November 11, 2002

RE: Proposed NIOSH Certification Standard for APR CBRN
 Federal Register Notice May 31, 2002 (Vol.67, Number 105, pg. 38127-38128)

Figure 1: Internal Thread

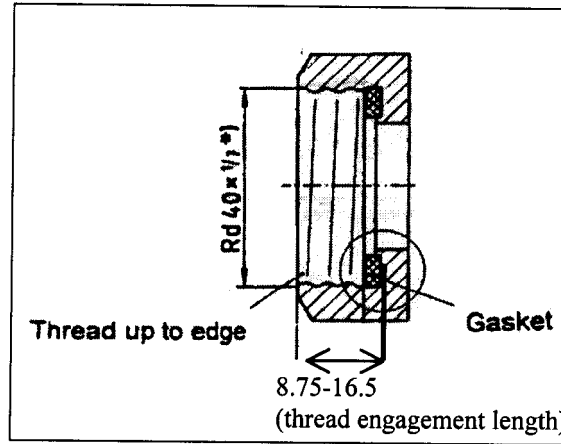
The specified thread in all three documents is RD 40 x 3.63 mm, but the internal thread depth on the facepiece specified in the Military Specification PD-EA-M-1801/E5-1-1054/D-1-1076 (Mil Spec) is shorter than what is required by EN 148-1 and NATO STANAG 4155. This was done to provide a lower profile full-face and faster canister attachment. It is important to note that this shorter internal thread is still compatible with the longer external thread of the EN 148-1. The internal thread height specification of EN 148-1 requires a thread engagement length (distance from bottom of gasket to edge) to be 15-16.5 mm, while the Mil Spec requires 8.75-9.25 mm.

Because the M40, MCU 2P and Millennium Gas military masks are compatible with the C2A1 military canister and EN 148-1 canisters, we suggest adapting the high end number (15-16.5 mm) for the internal thread from the EN 148-1 standard and the low end of the Mil Spec (8.75-9.25 mm) to make an internal thread length recommendation of 8.75-16.5 mm. Opening up the internal thread depth specification to accommodate both internal thread designs will allow existing US Military and First Responder respirator designs to be part of CBRN. This is shown in Figure 1.

Parameter	Requirement (mm)
Internal Thread – Thread Engagement Length	8.75 – 16.5 mm
External Thread – Run Out Length	15 mm
Gasket Thickness (minimum / maximum)	1.5 mm / 2.5 mm

Figure 2: External Thread

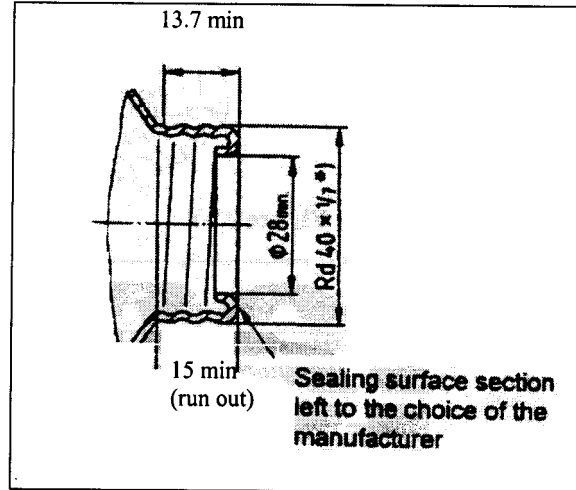
The NATO STANAG 4155 and EN 148.1 have a minimum external male thread run out of 16 mm, while the US Military Standard for the C2A1 minimum external male length is 15 mm. These minimum run out requirements are required to ensure the canister will seal with the gasket. Since the C2A1 canister is compatible with the EN 148-1 internal threads we recommend establishing the C2A1 minimum run out of 15 mm as the standard minimum run out for the APR CBRN standard. This is shown in Figure 2.
